Well Name: SOUTH BISTI 18H

Notice of Intent

Type of Action Plug and Abandonment

BLM - FFO - Geologic Report

Proposed Wellbore Diagram

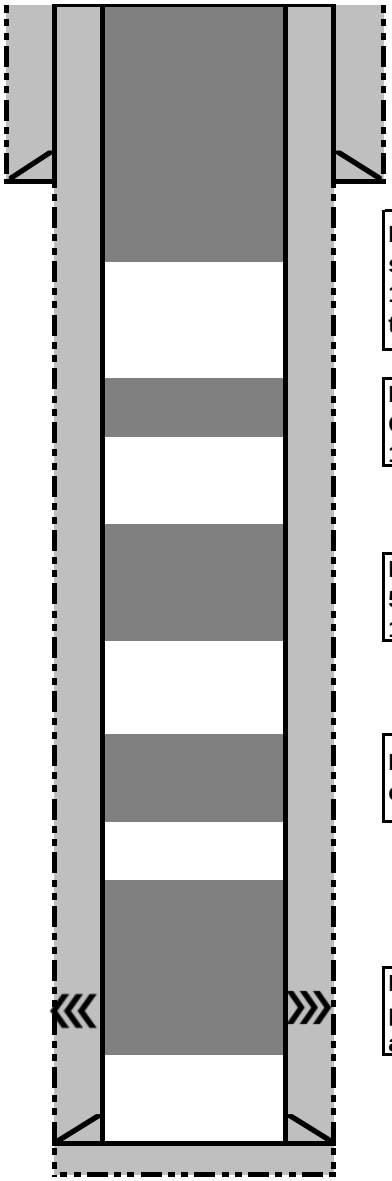
- BLM geologist's estimates for the tops of the Chacra, Cliff House, and the Menefee fms. vary from operator's estimates in this well.

-The tops and bottoms of Plugs 2 and 4 vary from The BLM geologist's formation depths. These plugs must be modified to match the BLM depths.
